**01** | SITE PLAN

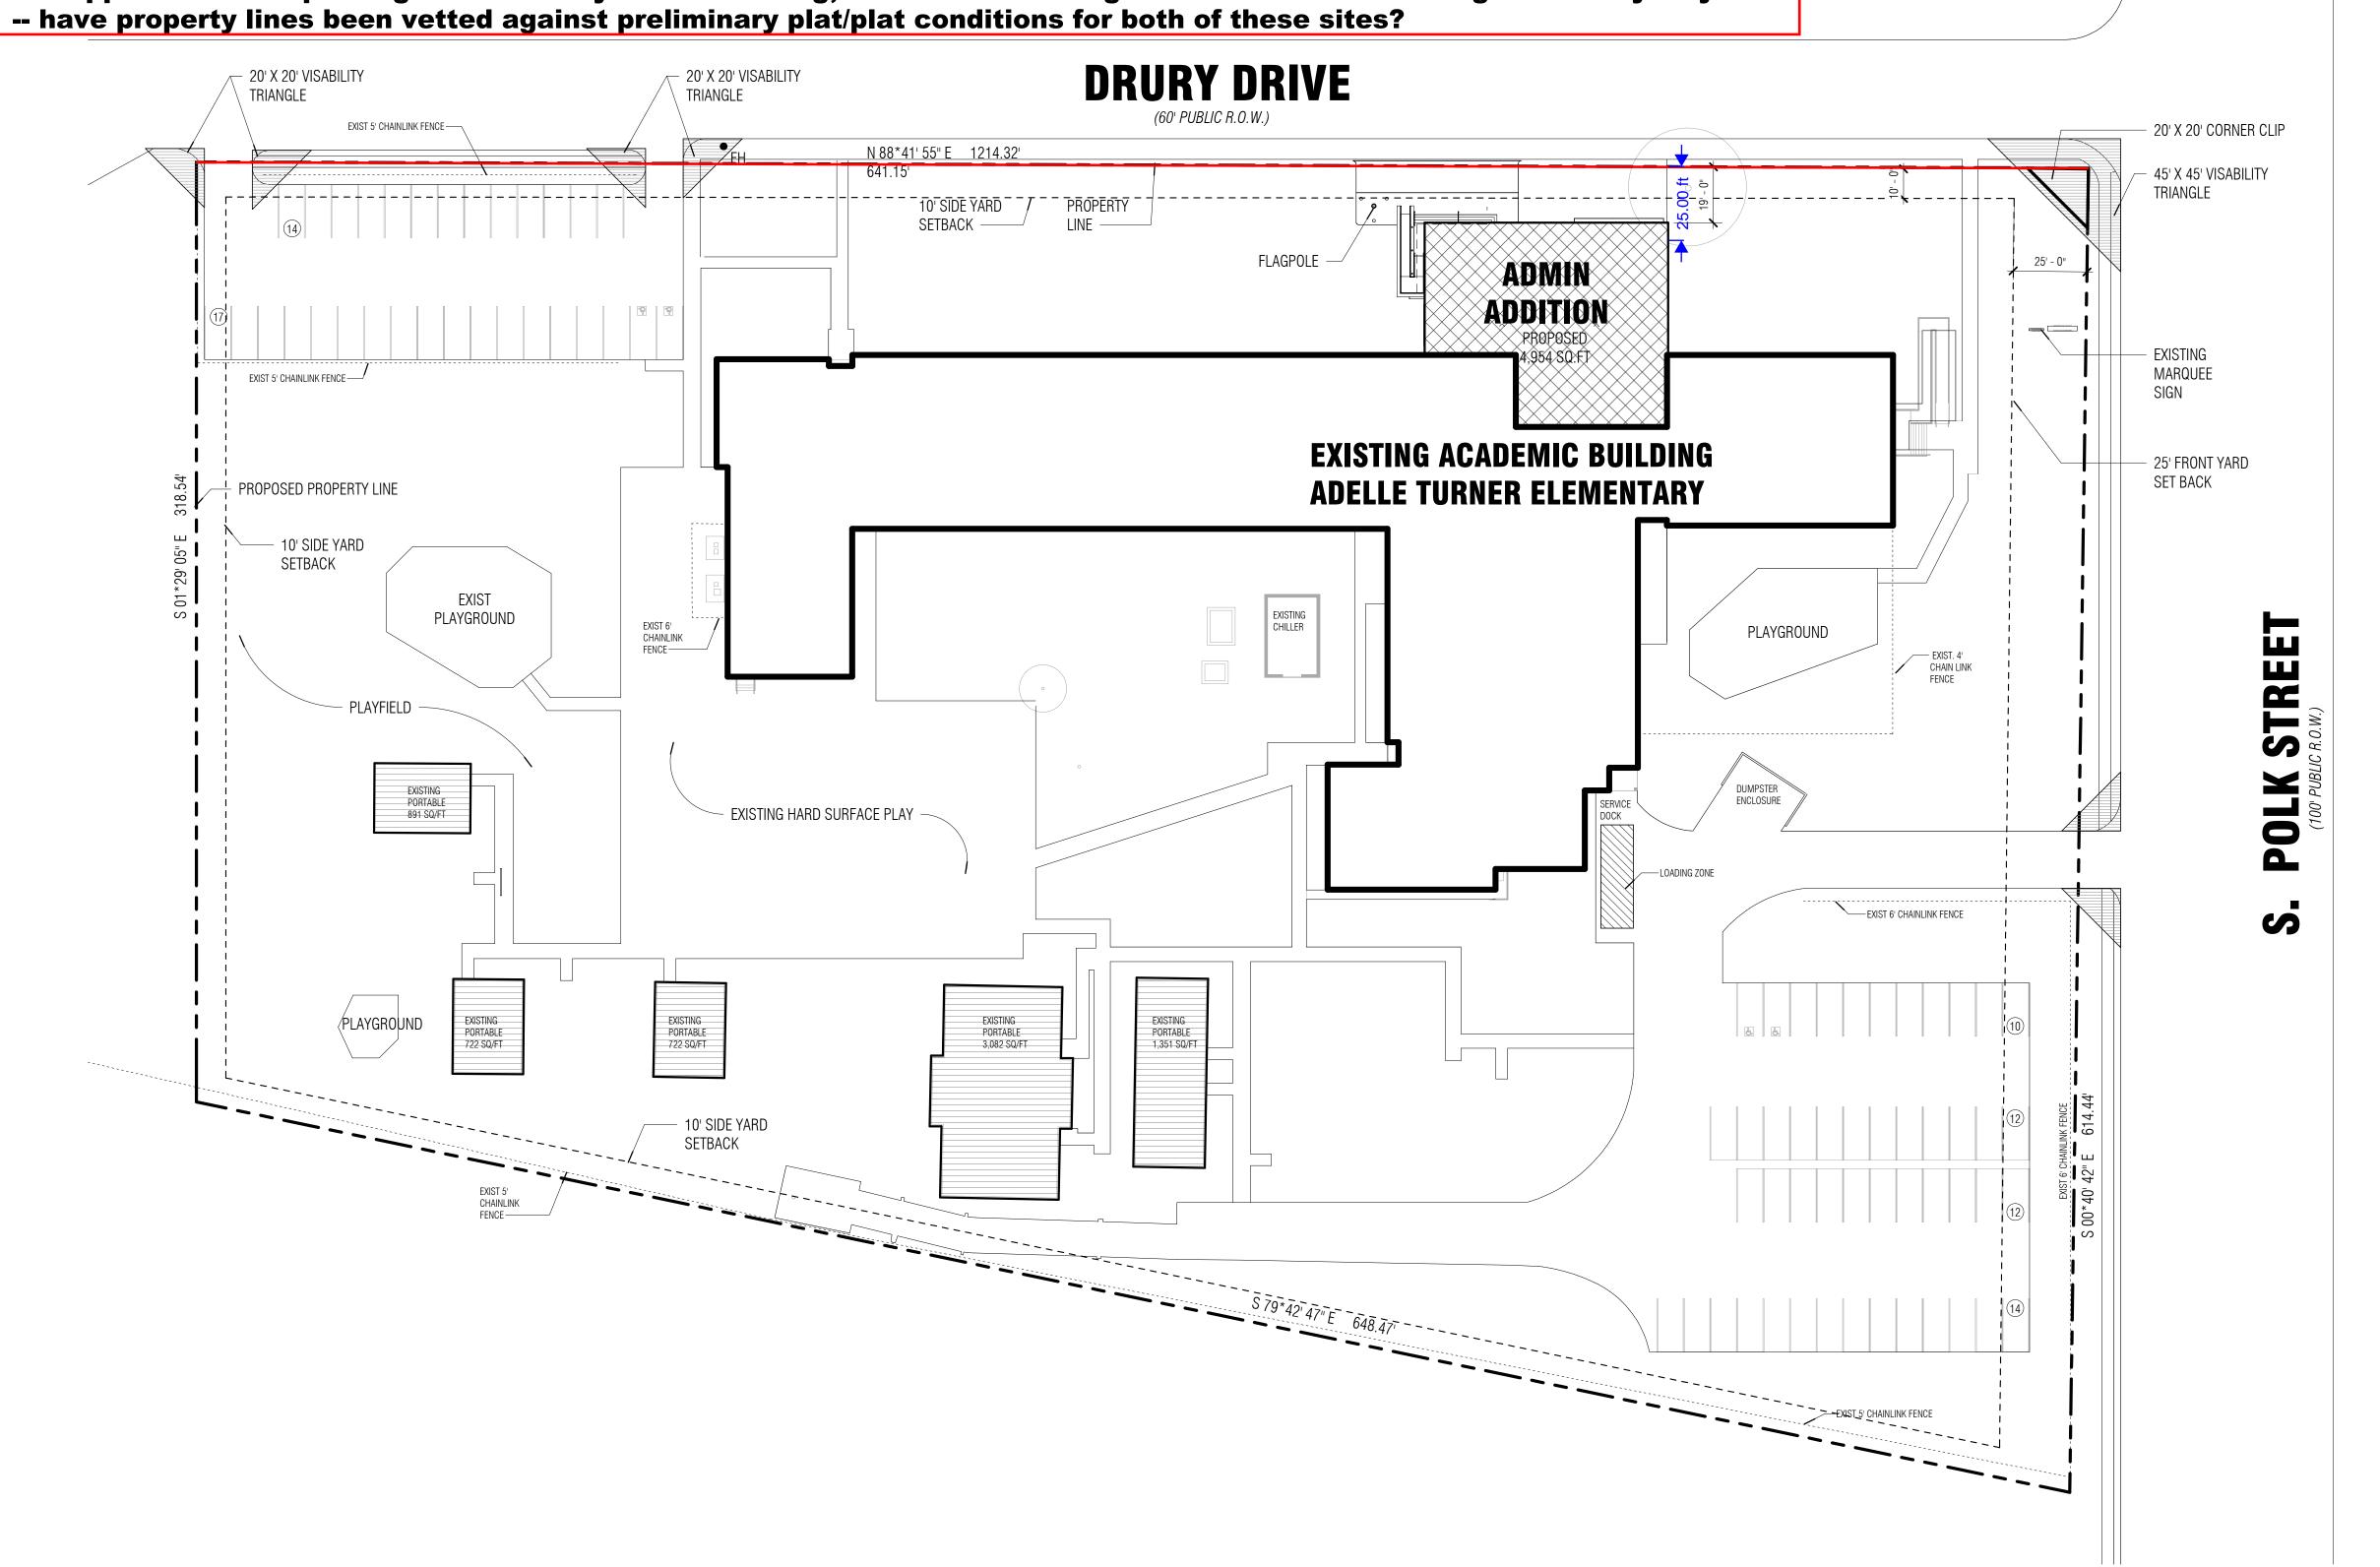
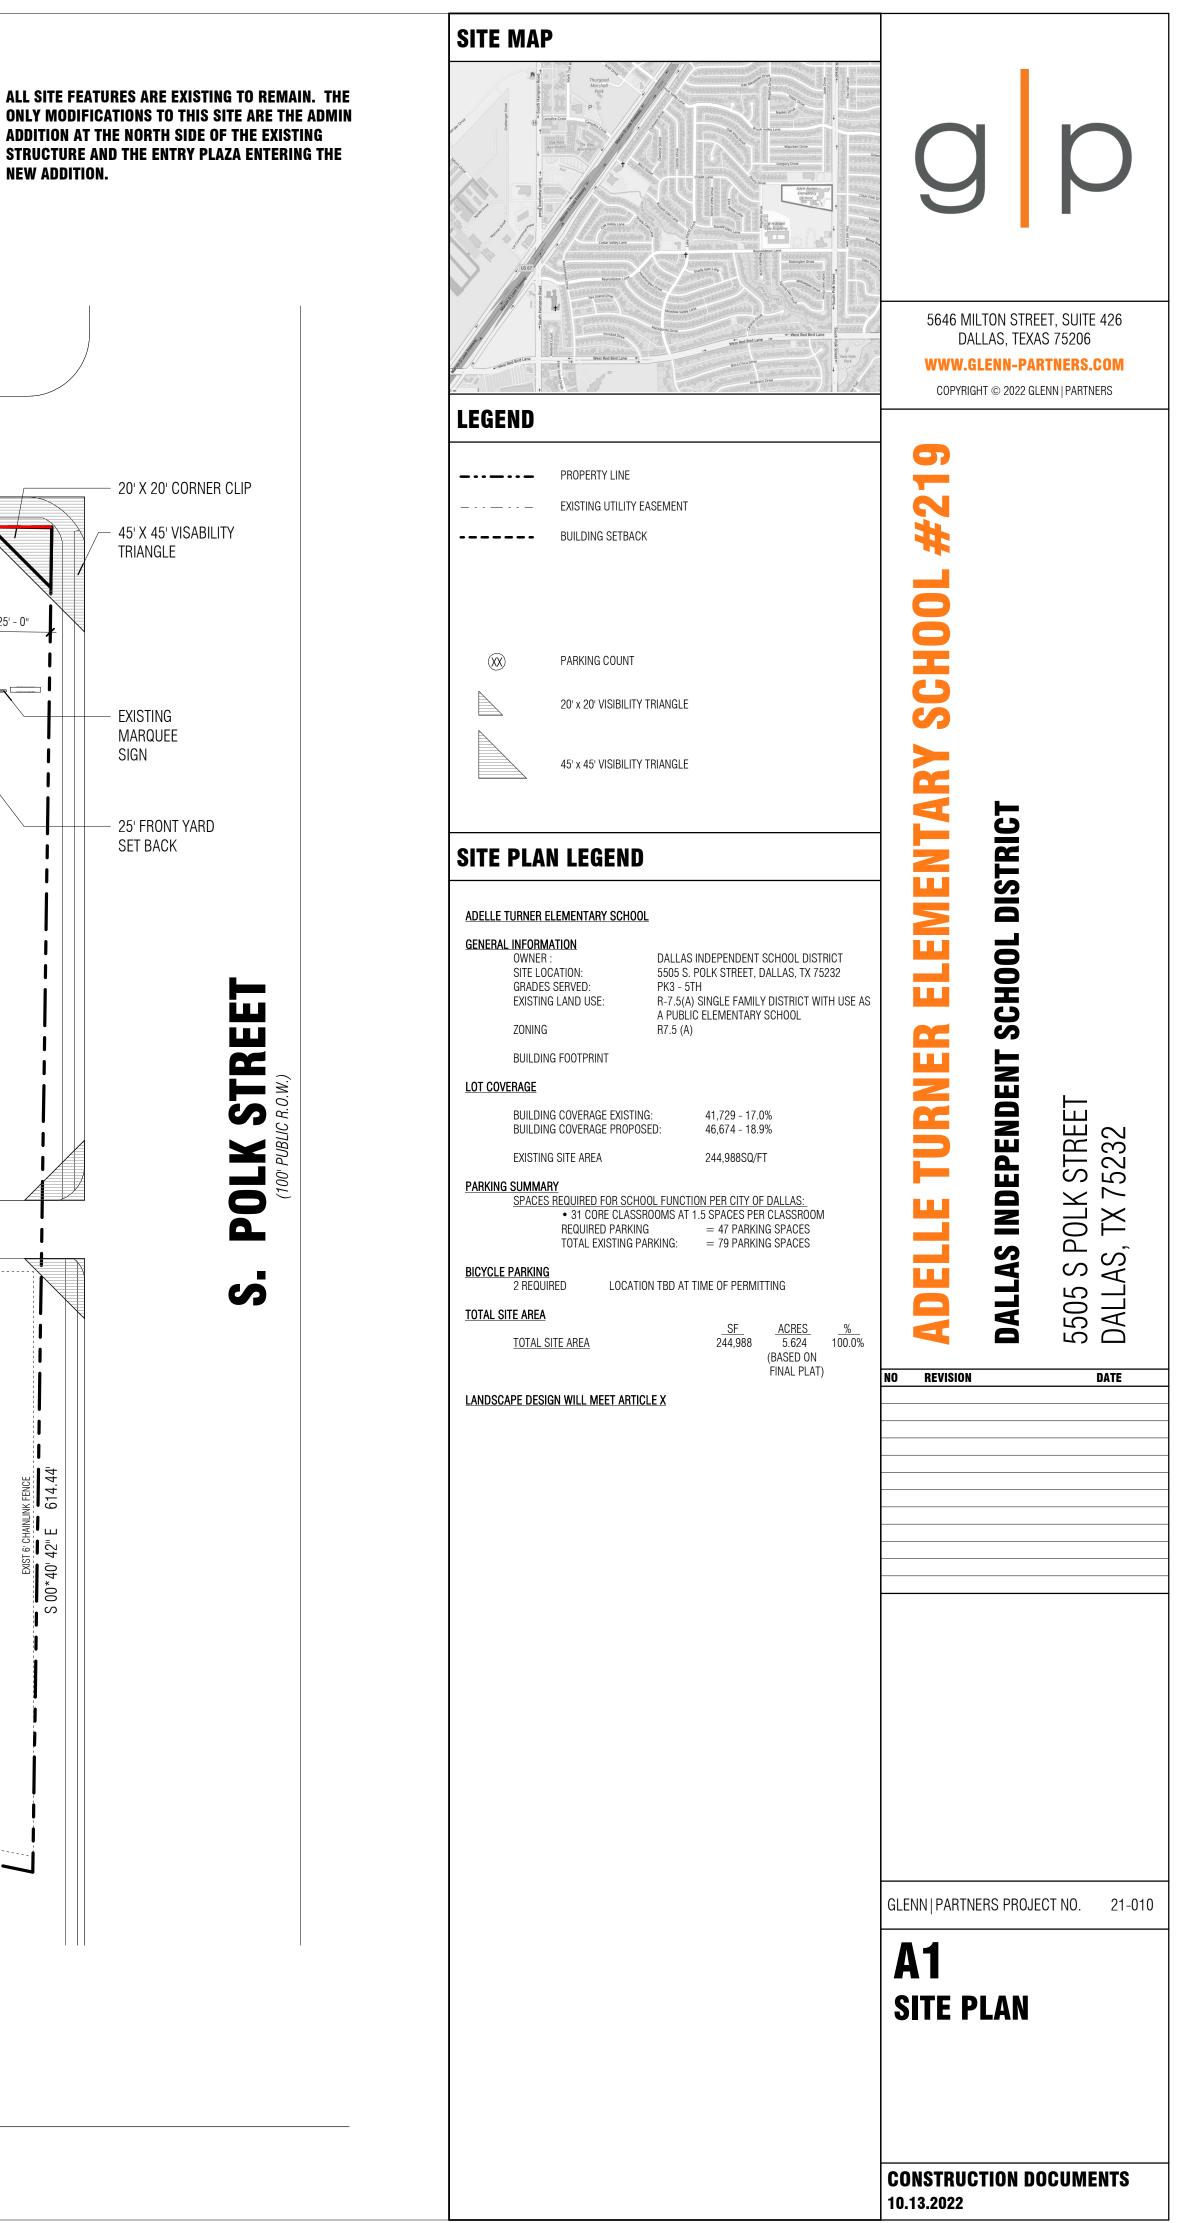
- -- drawing is not to the stated scale (ex: setback called out as 10' measures to 11')
- -- setback at Drury is 25' due to continuity with the adjacent lot (Drury is a front yard for the Atwell/Bedford lot) [refer to 25' setback line extended along Drury frontage on the site plan for Atwell/Bedford. overlay of plans shown below with Atwell/Bedford in grey and Turner in blue]

- -- proposed improvements may not encroach into 25' setback at Drury (existing improvements become nonconforming)
- -- it appears that all parking within front yards is existing, so no issue as long as these are not reconfigured in any way
